HISTORIC AND DESIGN REVIEW COMMISSION

February 06, 2019

HDRC CASE NO: 2019-025
ADDRESS: 321 E LOCUST
323 E LOCUST
LEGAL DESCRIPTION: NCB 1738 BLK 3 LOT 9 (TOBIN HILL URBAN BUNGALOWS II)
NCB 1738 BLK 3 LOT 10 (TOBIN HILL URBAN BUNGALOWS II)
ZONING: IDZ, H
CITY COUNCIL DIST.: 1
DISTRICT: Tobin Hill Historic District
APPLICANT: Mark Ruch
OWNER: Mark & Susan Ruch Kevin & Melissa Peterson
TYPE OF WORK: Installation of front yard fencing
APPLICATION RECEIVED: January 18, 2019
60-DAY REVIEW: March 19, 2019
REQUEST:

The applicant is requesting a Certificate of Appropriateness for approval to construct a front yard fence.

PLOT (SITE) PLAN

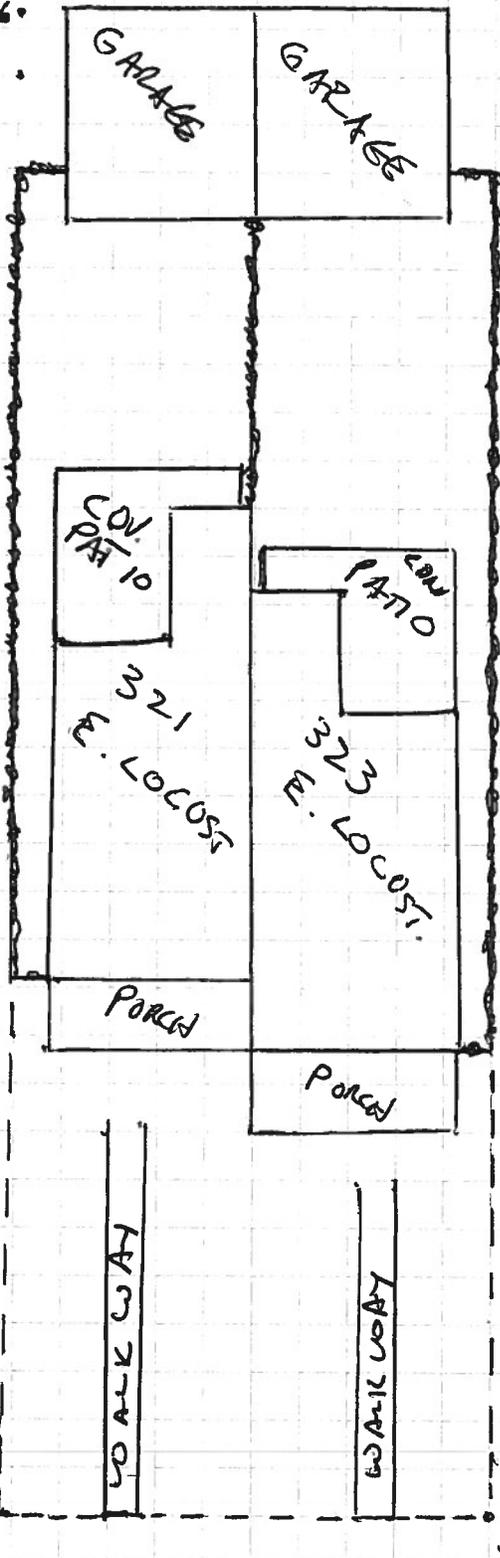
- a. FENCE LOCATION – The applicant has proposed to install a new front yard fence. Based on the submitted site plan, the fence will span the perimeter of the combined front yards. According to the Historic Design Guidelines, new front yard fences should follow historic fence placements in the district. Staff finds that the fence is consistent with the Guidelines.

Staff recommends approval based on findings a through c with the following stipulation:

- i. The final construction height of an approved fence may not exceed the maximum height as approved by the HDRC at any portion of the fence. Additionally, all fences must be permitted and meet the development standards outlined in UDC Section 35-514.
